Access Compliance Report Public Rights-of-Way (Curb Ramps)

Intersection ID: 46589Main Street:RABBITS_FOOT_LNCross Street:FERNHILL_DRLocation:WADA ID: 60ACE21ECD56Ramp Type:PerpDiagInitial Pass/Fail:FailOverall Compliance:NoSeverity Score:10

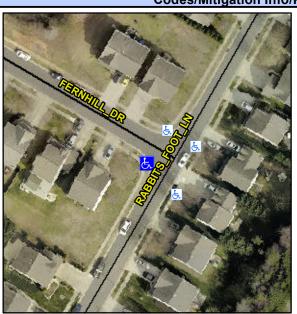
Not Found, R304.5.1, R304.5.3

Field Measurements/Component Compilance					
Compliance Description		Data	Compliance Description		Data
N/A	Ramp Length (in)	46.0	Yes	Ramp Slope (%)	6.5
No	Ramp Width (in)	38.0	No	Ramp XSlope (%)	2.9
N/A	Flare Type LT	N/A	N/A	Flare Type RT	N/A
N/A	Flare Slope LT (%)	N/A	N/A	Flare Slope RT (%)	N/A
N/A	Flare Traversable LT?	N/A	N/A	Flare Traversable RT?	N/A
N/A	Landing Length (in)	N/A	N/A	DWS Provided?	N/A
N/A	Landing Width (in)	N/A	N/A	DWS Contrast?	N/A
N/A	Landing Slope (%)	N/A	N/A	DWS Length (in)	N/A
N/A	Landing X Slope (%)	N/A	N/A	DWS Full Width?	N/A
N/A	Landing Curb? (Y/N)	N/A	N/A	DWS Offset (in)	N/A
N/A	Shared Landing?	N/A			
N/A	Gutter Ponding?	N/A	N/A	Gutter Slope (%)	N/A
N/A	Gutter Lip Ht (in)	N/A	N/A	Gutter X Slope (%)	N/A
N/A	Painted X Walk1?	No	N/A	Painted X Walk2?	No
	X Walk 1 Direction	To SE		X Walk 2 Direction	To NE
N/A	X Walk 1 Width (in)	N/A	N/A	X Walk 2 Width (in)	N/A
	X Walk 1 Slope (%)	2.8		X Walk 2 Slope (%)	2.8

Remove & Replace Curb Ramp With Two New Directional Ramps or Equivalent.
